AMENDMENT TO THE DRAWING

REMARKS

FIG 1

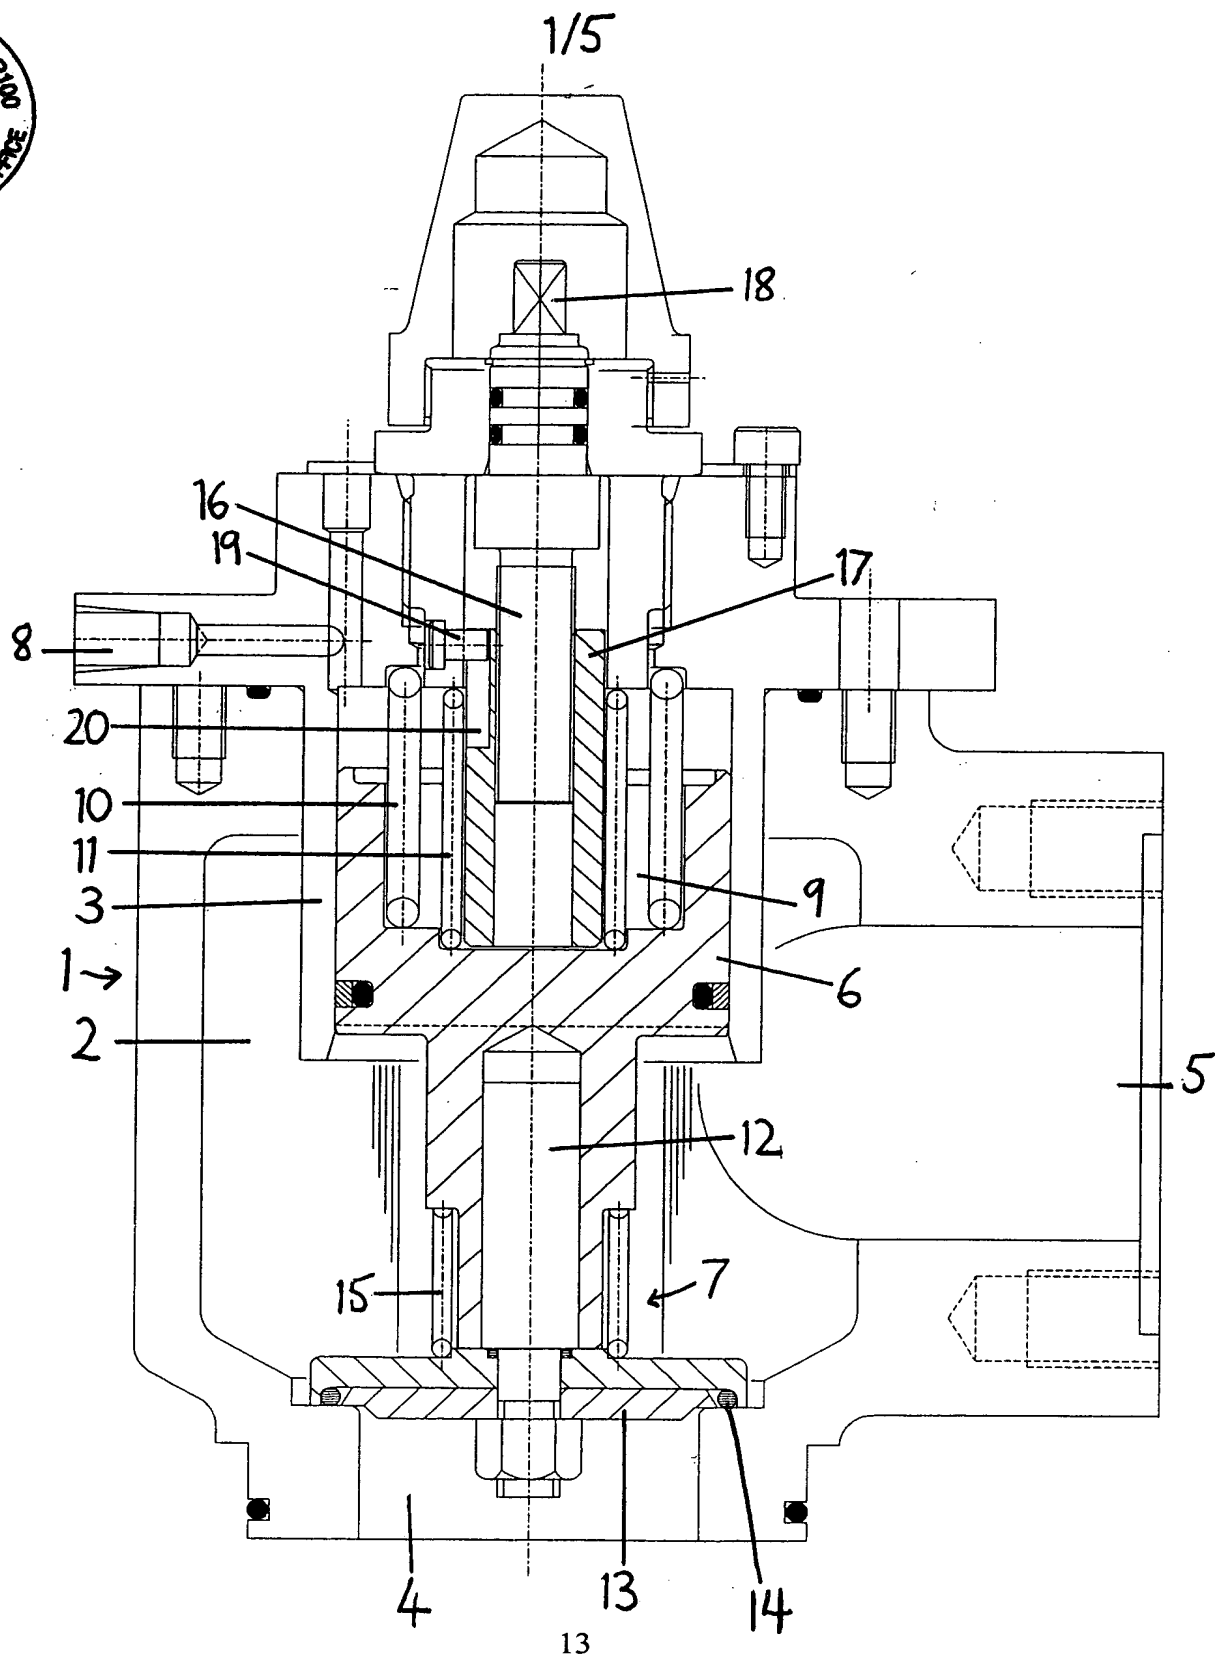
In FIGURE 1:

Add the numeral "14" for the O-ring associated with closing disk 13.

The drawing is objected to because the identification numeral "14" which appears in the specification does not appear in the drawing. The drawing is amended at Figure 1 to add the identification numeral "14" for consistency with the specification. Specifically, the numeral "14" is added to identify the O-ring associated with closing disk 13, as shown on the red-line copy of Figure 1 herewith. Support for the amendment is found, for example, in the specification at page 5 , line 14. Replacement drawing sheets including the foregoing amendment are submitted herewith.
